| 2   | ISSUED FOR ADDENDUM 3, REVISED LOAD CENTRE DESCRIPTION FOR 40A WAS CHQM1224M002C. BREAKER 10 kAIC WAS 22kAIC                | DTA | 2025-07-24 |

PROJECT  
**PARKS & OPEN SPACE DIVISION**  
**BUNN'S CREEK PARK - STORAGE GARAGE**

SHEET TITLE  
**SITE AND FLOOR PLANS**  
**ELECTRICAL - DEMO AND RENO**  
**POWER AND SPECIFICATIONS**

| SCALE<br>AS SHOWN | PROJECT No:<br>2023-049 | SHEET No:<br><b>E1-R2</b> |

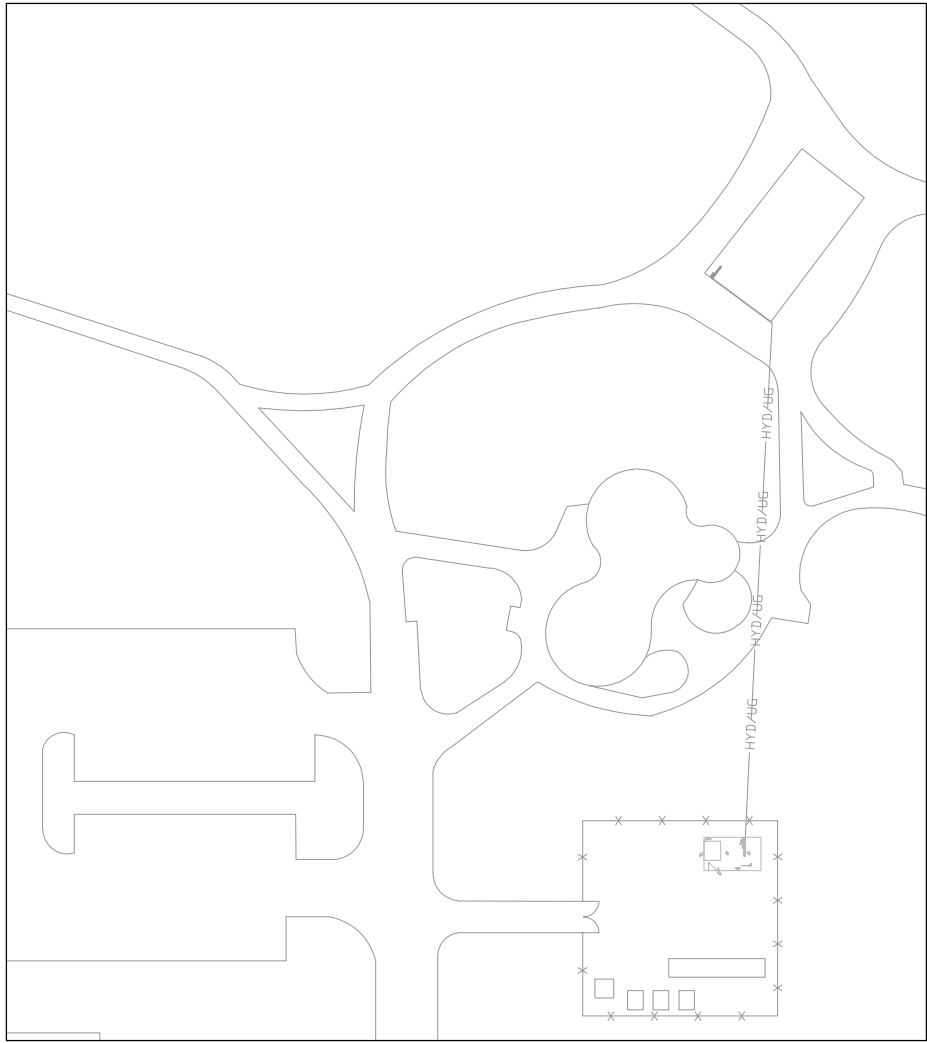
| 1   | REMOVED BRANCH CIRCUIT 100-3 (2) RECEPTACLES FROM 100-5 100-7 WAS 20A CB. REDUCED LOADS ON 100-7, 100-2, 100-4 & 100-10, 12 | DTA | 2025-06-03 |
